ADDENDUM

ADDENDUM NO: 1

PROJECT: BCSC Central Middle School Interior Renovation

PROJECT NO: 2024027

1 SECOND FLOOR - DEMOLITION PLAN
A200 SCALE: 1/8" = 1'-0"

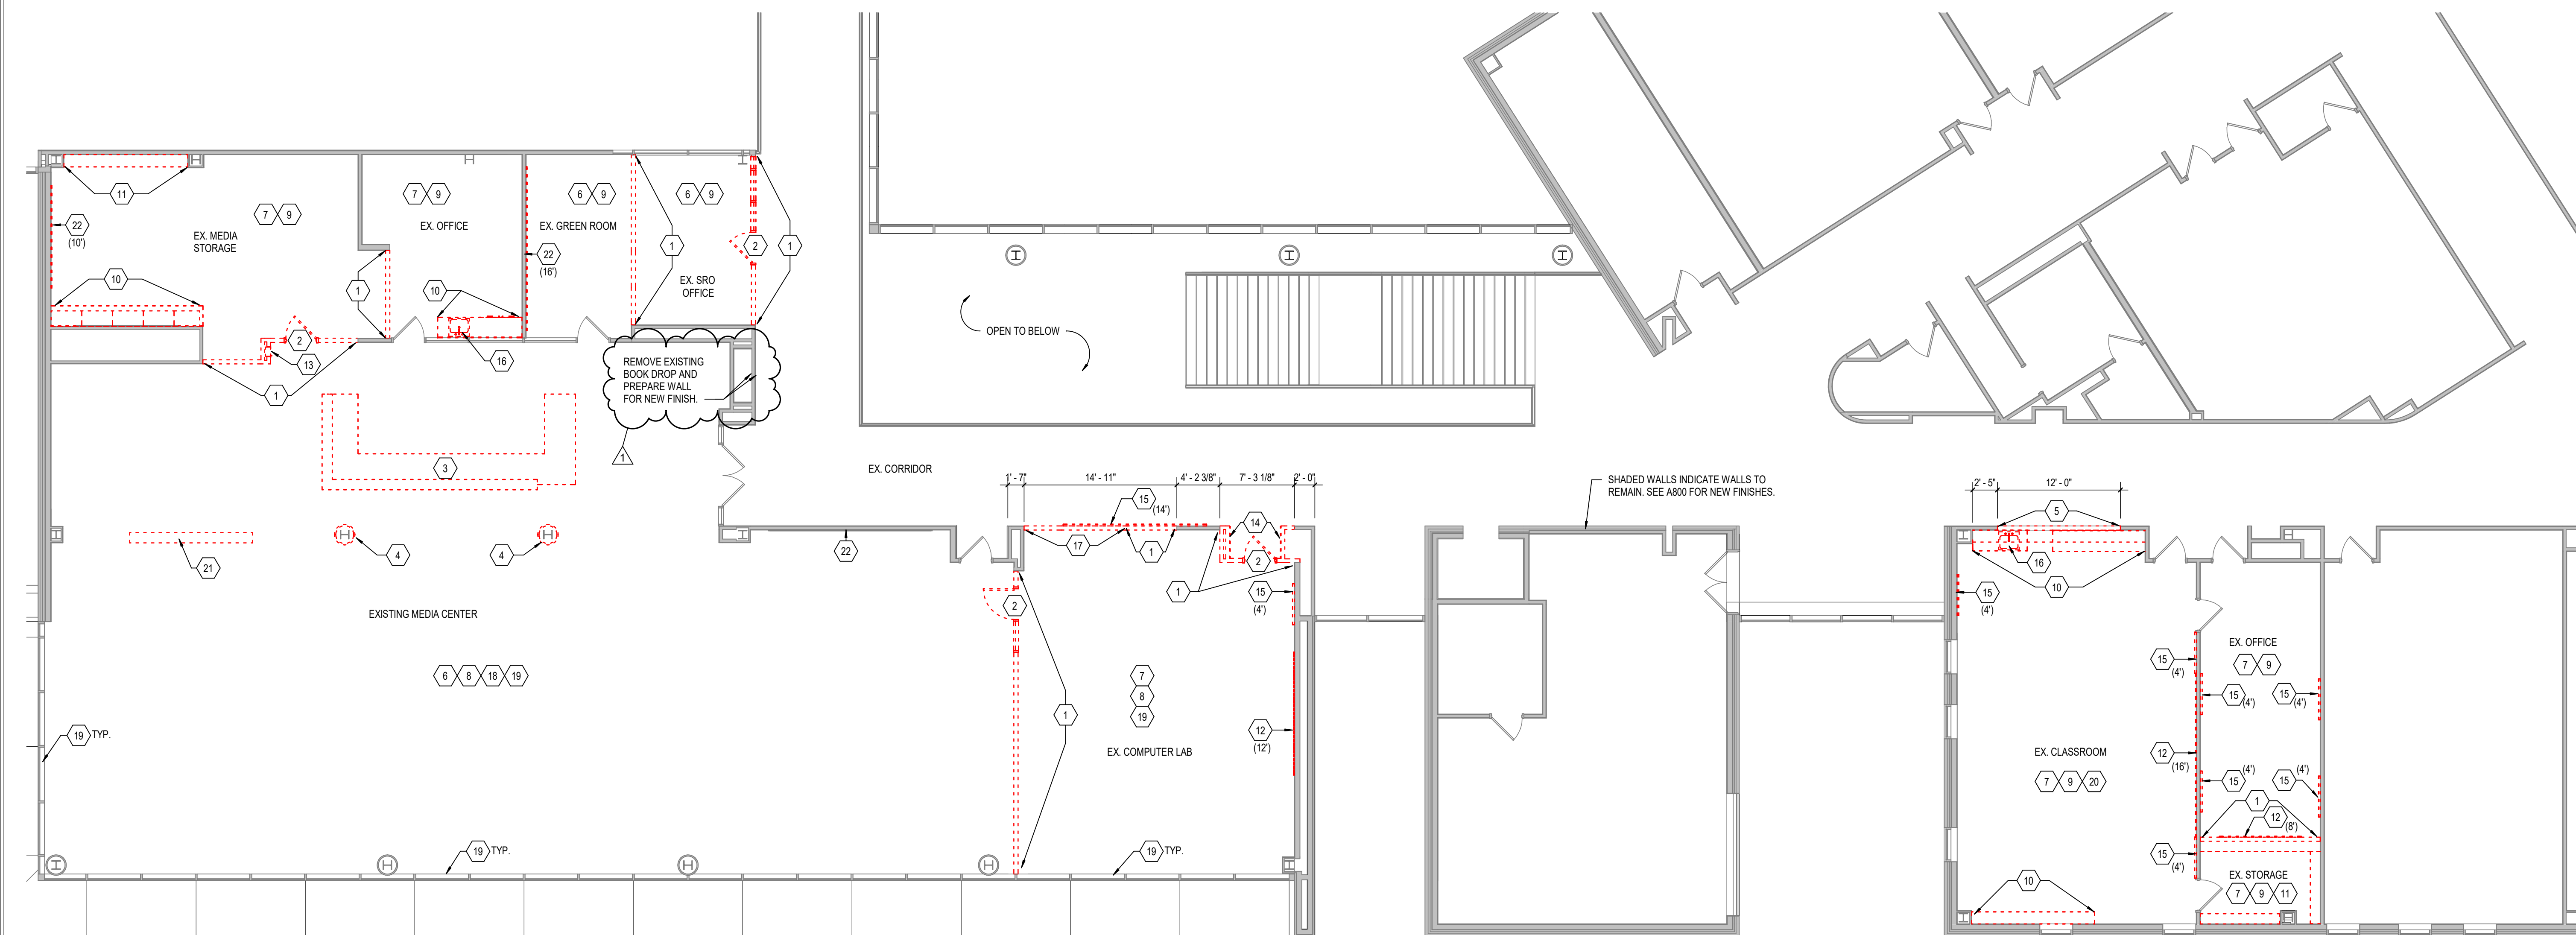
3.01 A200 – SECOND FLOOR DEMOLITION AND LIFE SAFETY PLANS

- A. Revise Keyed Demolition Note #19 to read:

19. REMOVE EXISTING ROLLER SHADES ALONG EXTERIOR WINDOWS. RETURN TO OWNER. BY ALTERNATE ONLY.
- B. 1/A200: Add demolition note to demolish existing book drop between the corridor and media center.

2 SECOND FLOOR - REFLECTED CEILING PLAN
SCALE: 1/8" = 1'-0"

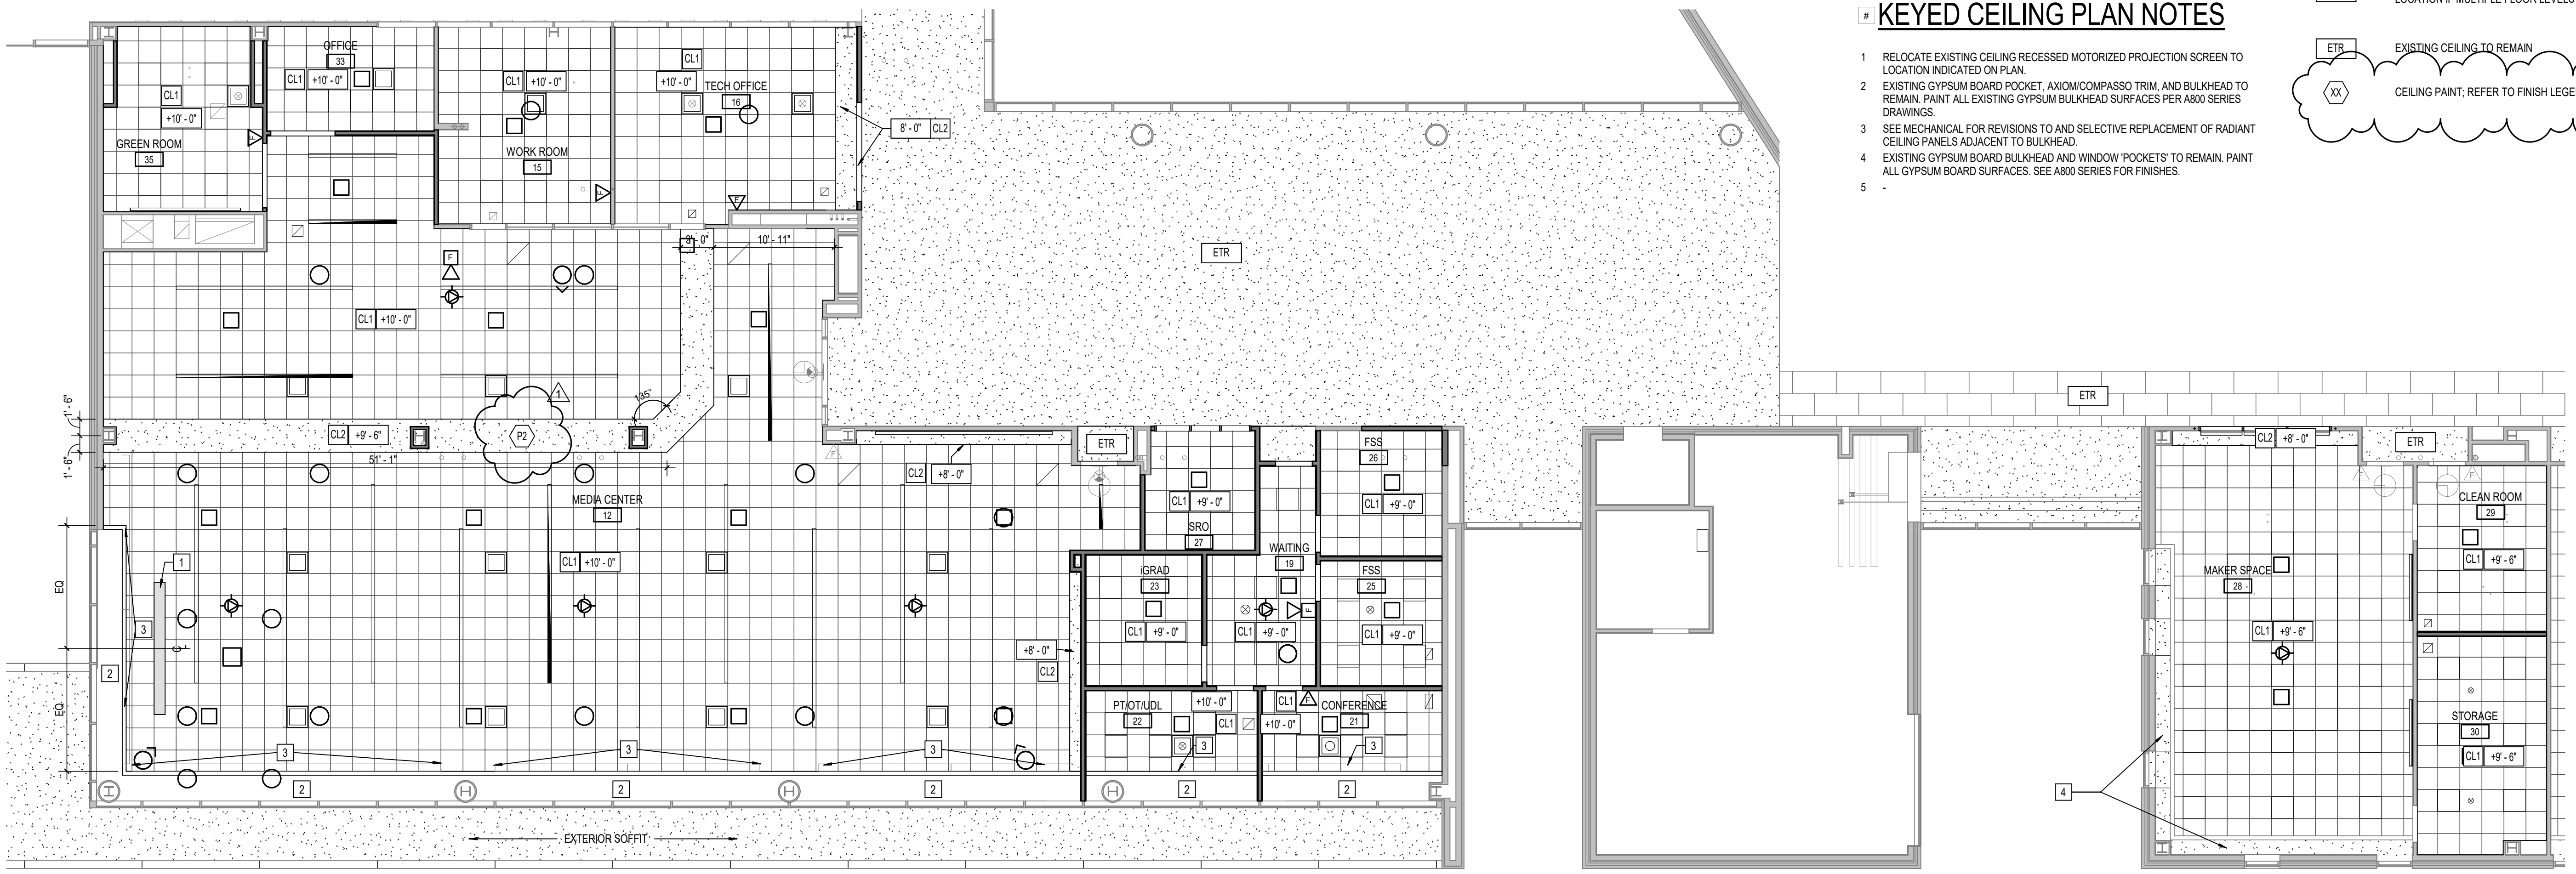
- A. 1/A201: Add plan note 6 at location of existing book return.
- B. Reflected Ceiling Legend: Add ceiling paint tag.
- C. 2/A201: Add ceiling paint tag “P2” to bulkhead.

1 SECOND FLOOR - FLOOR PLAN
SCALE: 1/8" = 1'-0"

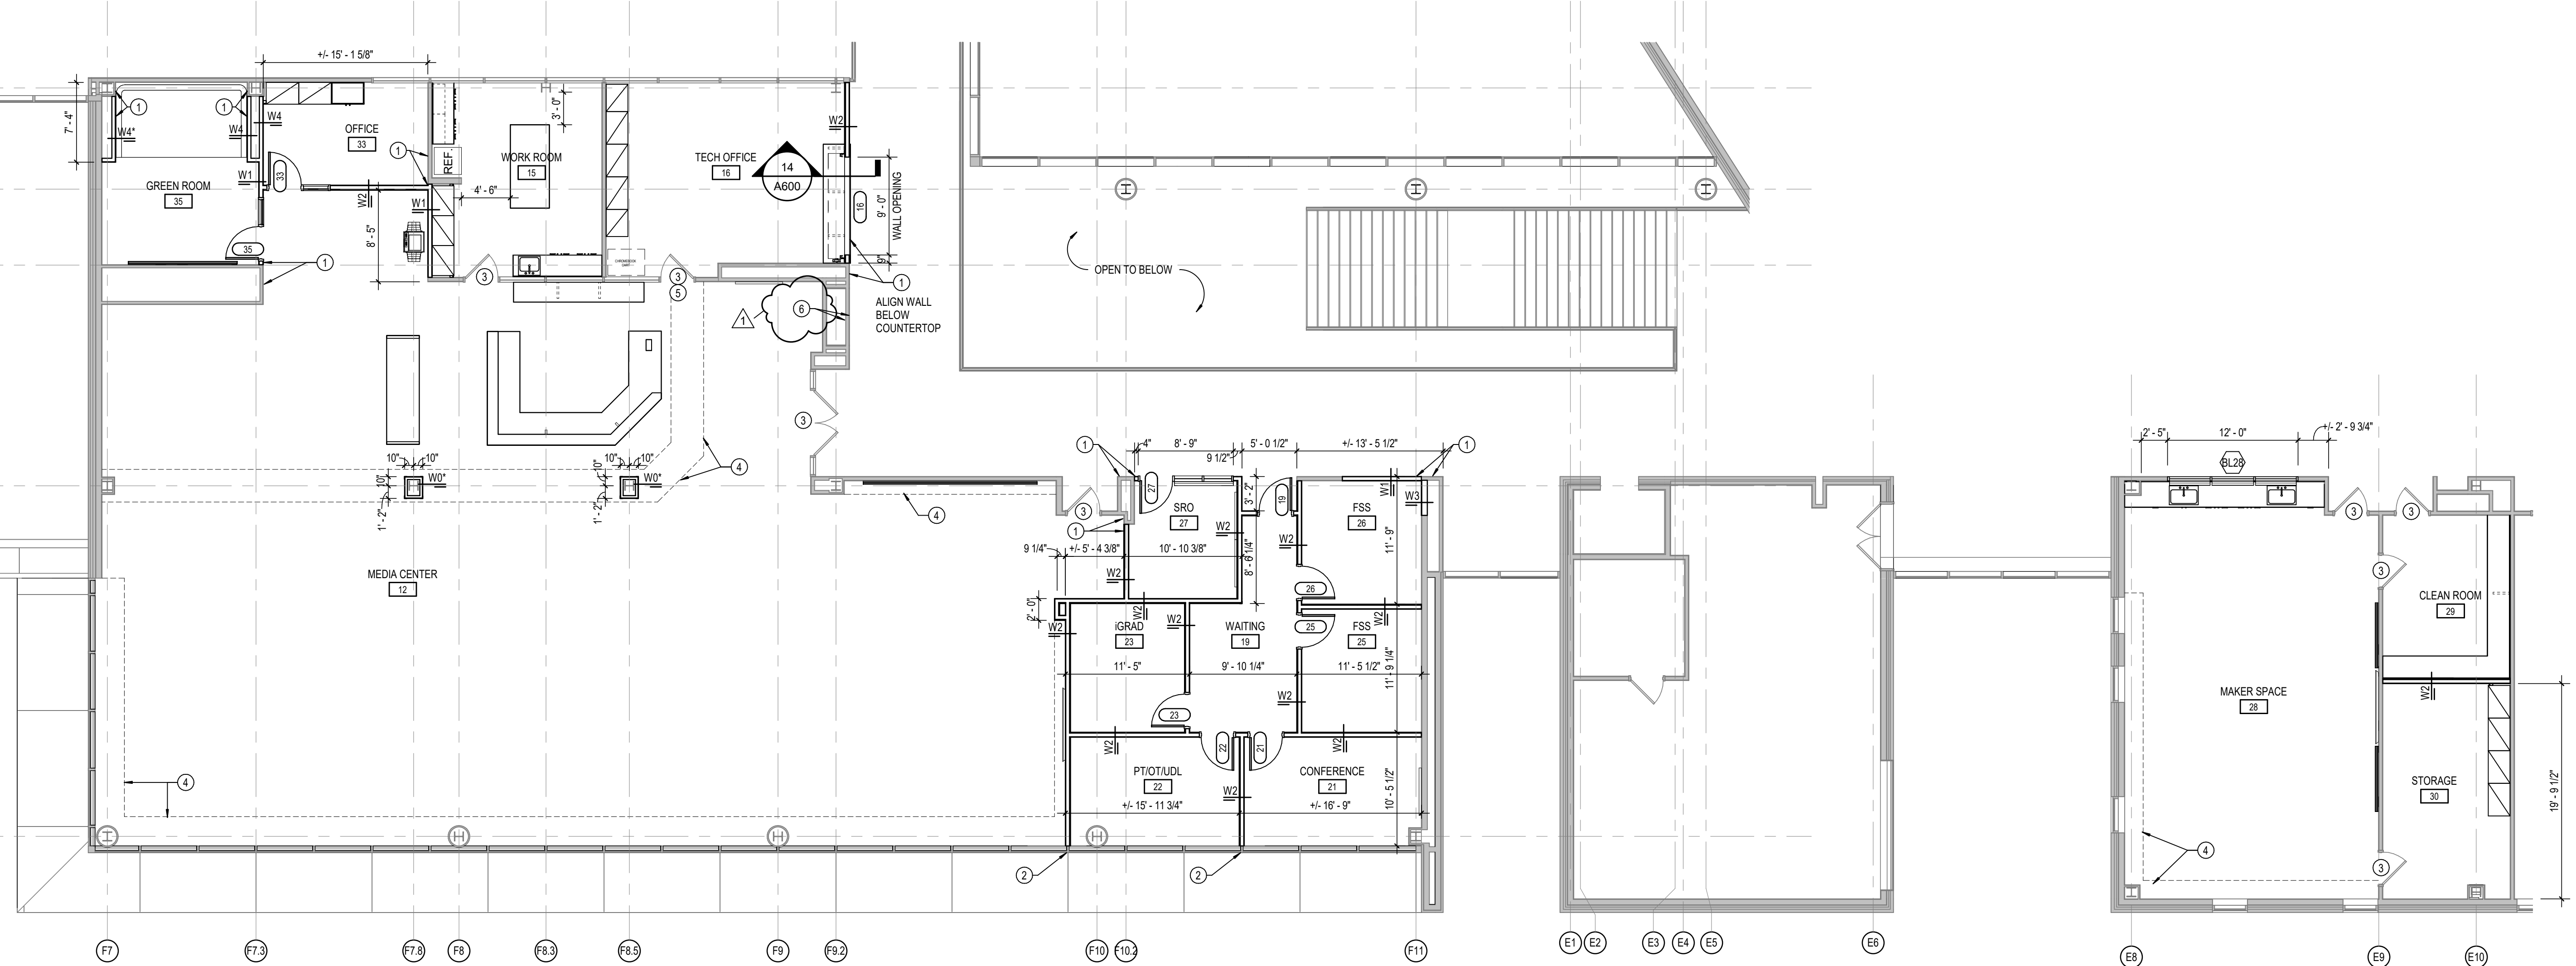
3.02 A201 – SECOND FLOOR PLAN AND REFLECTED CEILING PLAN

1 MEDIA CENTER - FINISH PLAN
SCALE: 1/8" = 1'-0"

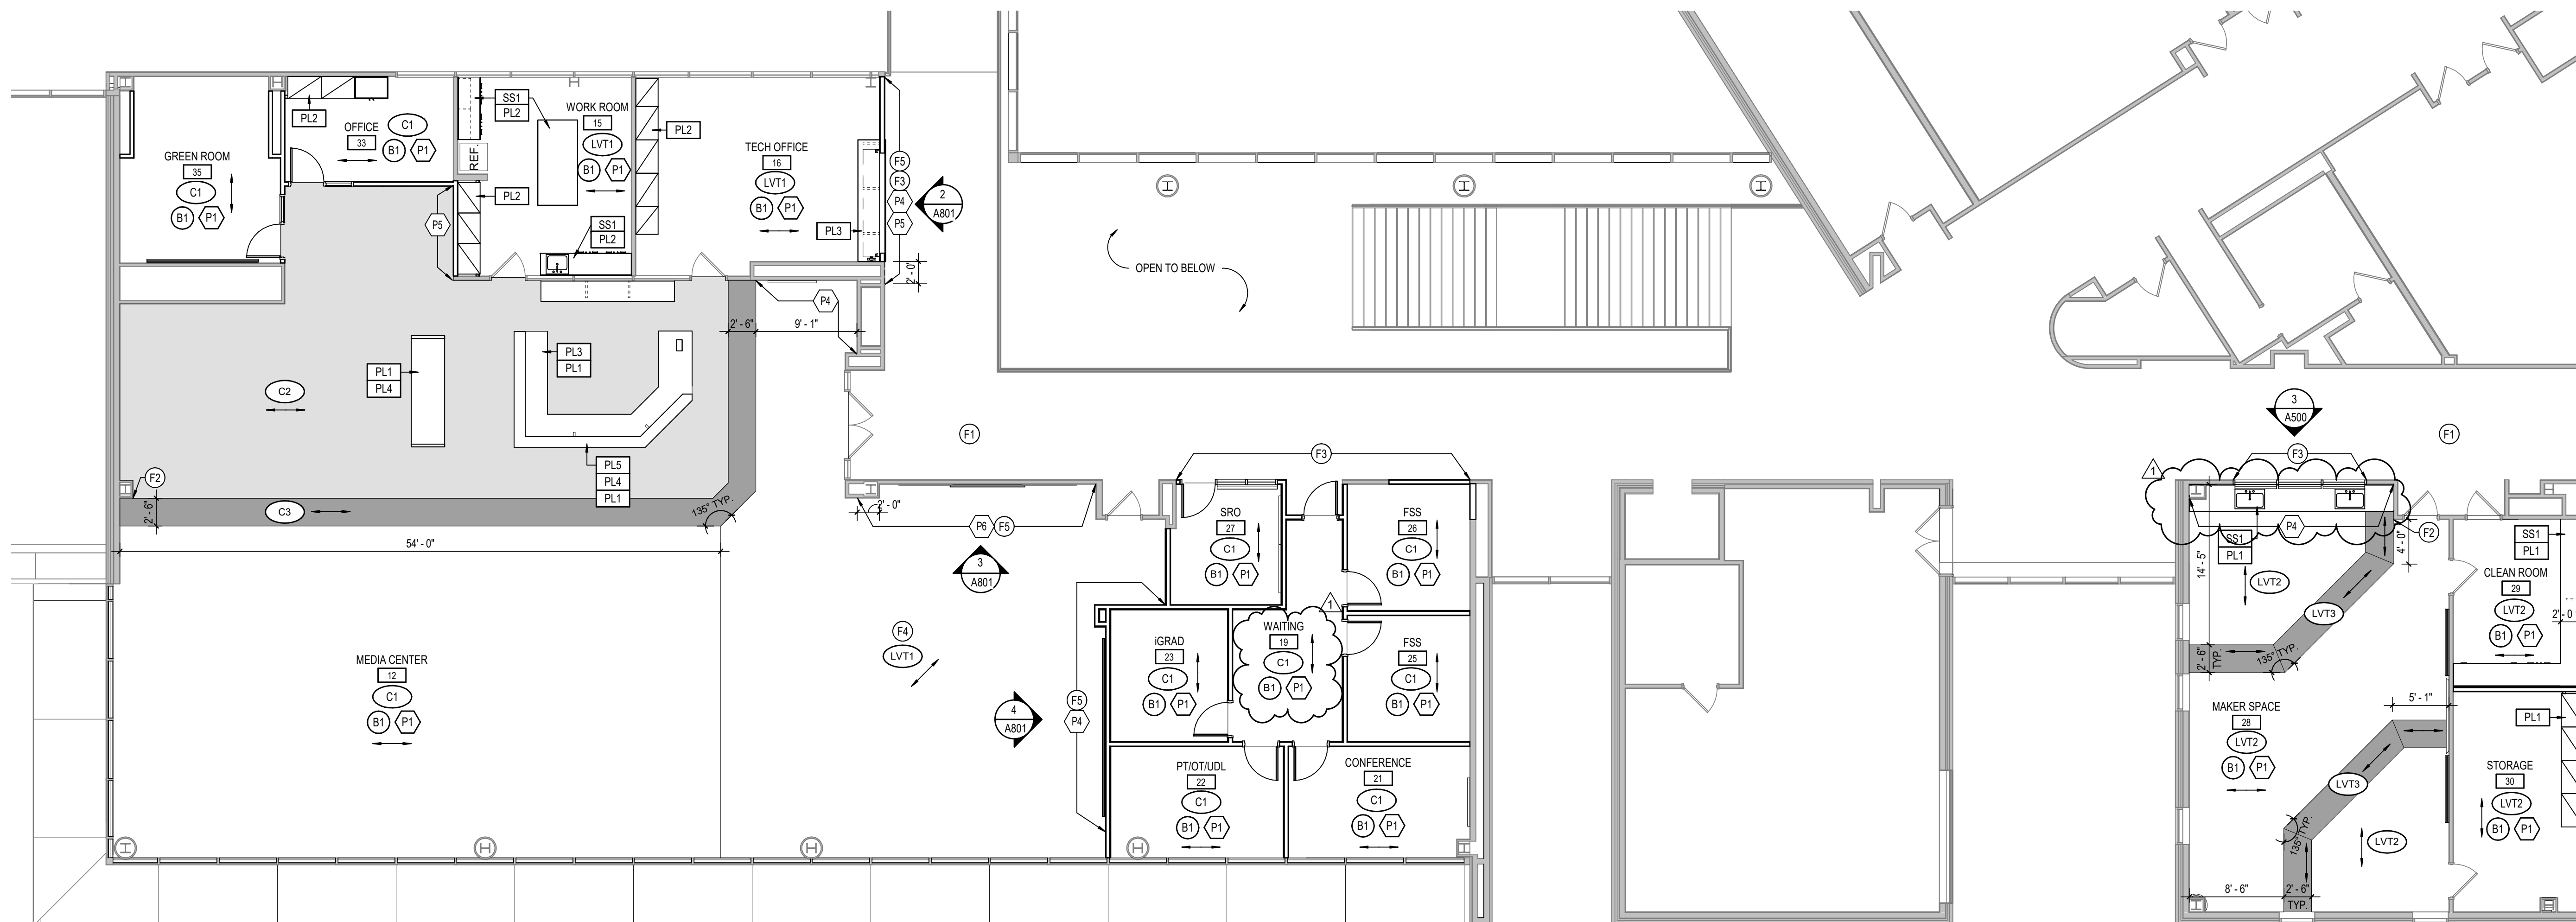
3.03 A801 – FINISH LEGEND, DETAILS, & MEDIA CENTER FINISH PLAN

- A. Finish Legend: Update note to say “Neutral Accent Ceiling Paint”.
- B. 1/A801: Add “P4” wall accent paint tag in “Maker Space 28”.
- C. 1/A801: Update flooring tag to “C1” in “Waiting 19”.
- D. 3/A801: Equipment tag updated, center on wall as shown.
- E. 4/A801: Equipment tag updated, center on wall as shown.
